To: Jim Well
Ducks Unlimited
From: Yantao Cui, Ph.D.,
Senior Hydraulic Engineer
Date: 29 May 2013
Number of pages: 3
Subject: M&T Pump Intake Relocation to the West Bank of the Sacramento River

In this technical memorandum I provide a technical review of the technical memorandum authored by Dai Thomas, Bob Mussetter, and Mike Harvey of Tetra Tech dated 27 May 2013 titled “Evaluation of the Proposed M&T Pump Intake on the West Bank of the Sacramento River, Project No. US-CA-62-5” (the Tetra Tech Memo hereafter), as you requested.

Figure i. 2012 aerial photograph of the study reach, showing the 1999 channel alignment of the two banks (red lines) and the direction of channel migration (yellow arrows) over the 13-year period.

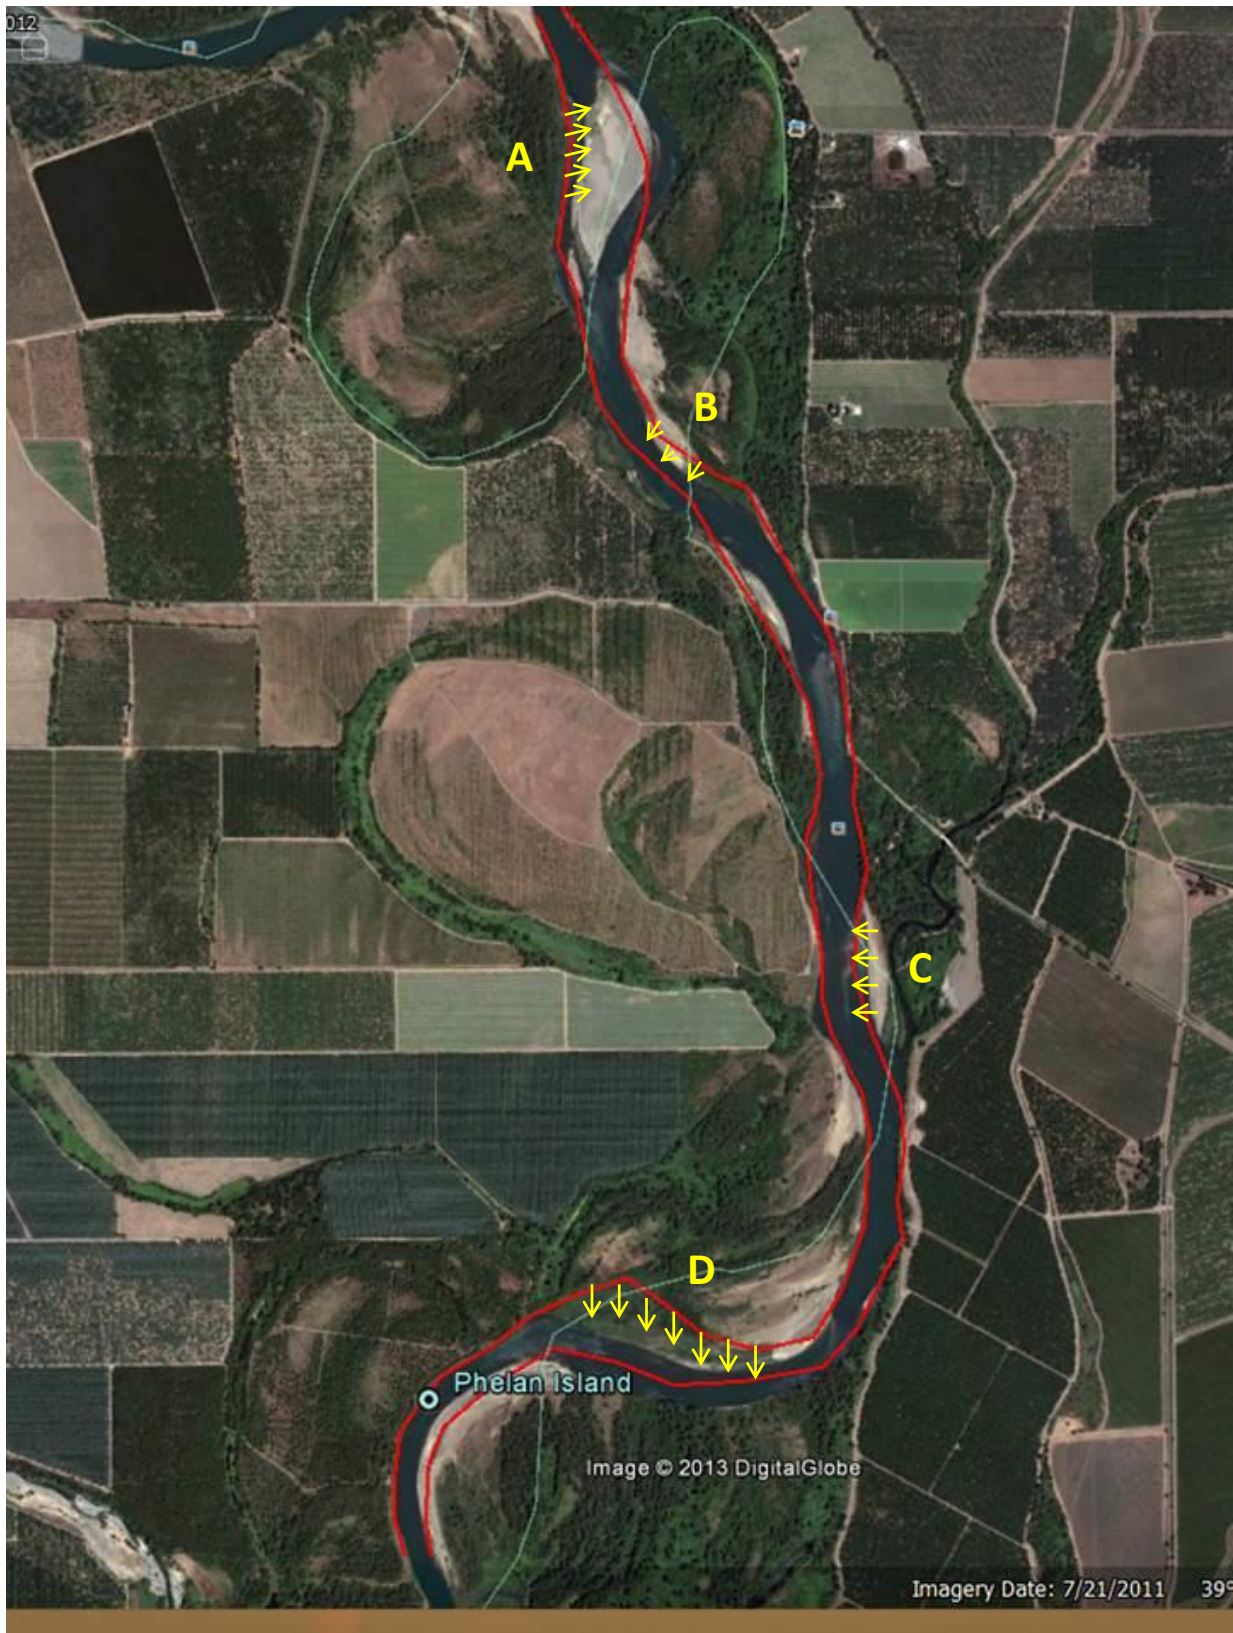
- (b) **The implication of continued channel migration:** Although the rock toe has fixed the river in the current location temporarily, the Sacramento River continues to migrate in the upstream and downstream reaches away from the rock toe. Comparison of the 2012 aerial photograph with the 1999 bank alignments obtained from 1999 aerial photograph (Figure i), for example, indicates eastward migration in area labeled A, westward migration in area labeled B, and southward migration in area labeled D. The vicinity of the current and planned west bank intake locations (area labeled C), however, is relatively straight, largely due to the dredging of the gravel bar and the installation of the rock toe. As the channel migration upstream and downstream of the study reach accumulates over time, we are unsure what will be the local effects on water depth and what time will it take to have these known effects to take place. A discussion about such risks will be helpful.
